REVISED RESPONSE TO REQUEST FOR ADDITIONAL INFORMATION

APR1400 Design Certification

Docket No. 52-046

RAI No.: 255-8285
SRP Section: 03.08.05 – Foundations
Application Section: 03.08.05
Date of RAI Issue: 10/19/2015

Figure 2-5 Variation of Shear Modulus with Shear Strain for Sands

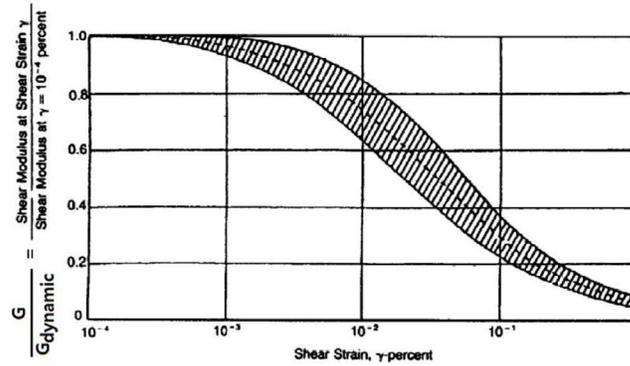
4. APR1400-E-S-NR-14006-P, Rev.1, Section 2.2.1 indicated that the relationship between Elastic and $E_{dynamic}$ at the soil site is 0.1153. This ratio appears to be extremely low and is probably due to the questions raised in Item (a) and (b) above. The applicant is requested to update the approach to calculating $E_{static}/E_{dynamic}$ and confirm the adequacy of the resulting ratio based on other sources of information and industry practice.

According to in ASCE 4-98 C.3.3.2.2 (Ref.15) and Seed & Idriss (1970) (Ref.21), regarding reduction factor 0.1153, the shear modulus with shear strain level for sand varies as shown in Figure 2-5. Here G is the dynamic shear modulus at very low strain (less than 0.0001%) and $G_d = \rho V_s^2$.

Figure 2-5 demonstrates that the reduction of shear modulus with strain level for sand and the typical variability in the relationship. Generic data from the many field and laboratory test results supported the nonlinear behavior of soil with strain level, as shown in the figure.

Figure 3-13 Boundary Condition of Foundation Media Model

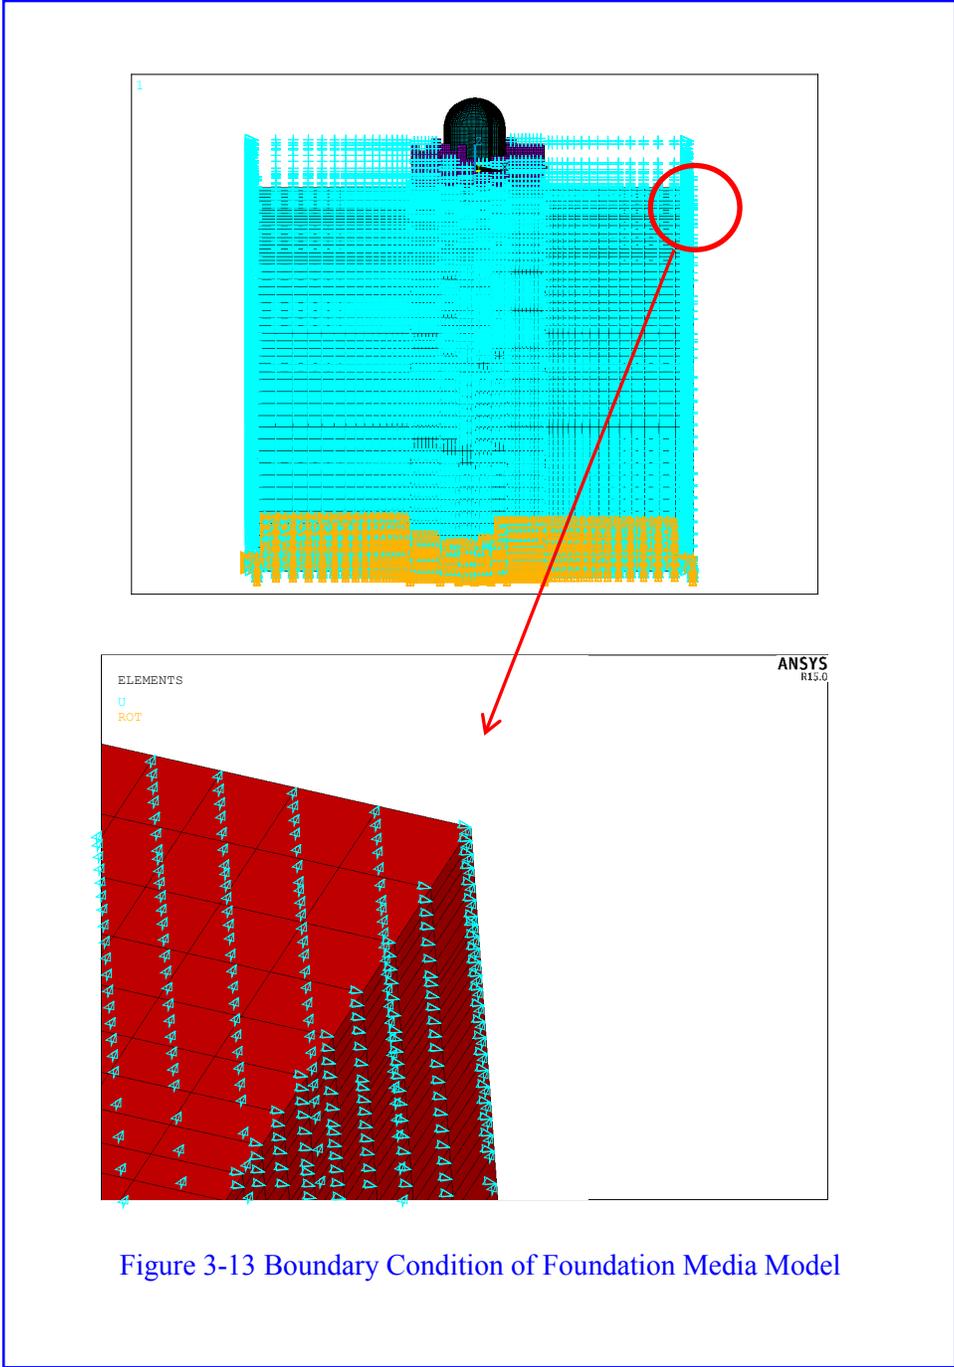
- c. In Section 2.3, "Material Properties and subgrade Modulus of Site Profiles for the APR1400," it is stated, "The subgrade moduli of three site profiles are obtained from an ANSYS analysis." The description of the development of the moduli should be expanded in order to understand the approach used. The applicant is requested to provide an explanation of the following: (1) whether only a vertical static 1 ksf load was applied to obtain the vertical soil moduli, (2) whether the vertical load was applied only to the basemat foundation region, (3) what is the technical basis for indicating that the horizontal subgrade moduli were determined using two-thirds of the horizontal displacement caused by what appears to be a vertically applied pressure load, and (4) if the LINK180 ANSYS element is only utilized to represent the soil in the settlement analysis and construction sequence, why is the horizontal moduli needed.

Technical report APR1400-E-S-NR-14006-P/NP, Rev.3 Subsection 3.2.4 Figure 3-13 will be revised or added, as indicated in Attachment 5.

Figure 3-13 shows the foundation media model application as the boundary condition.
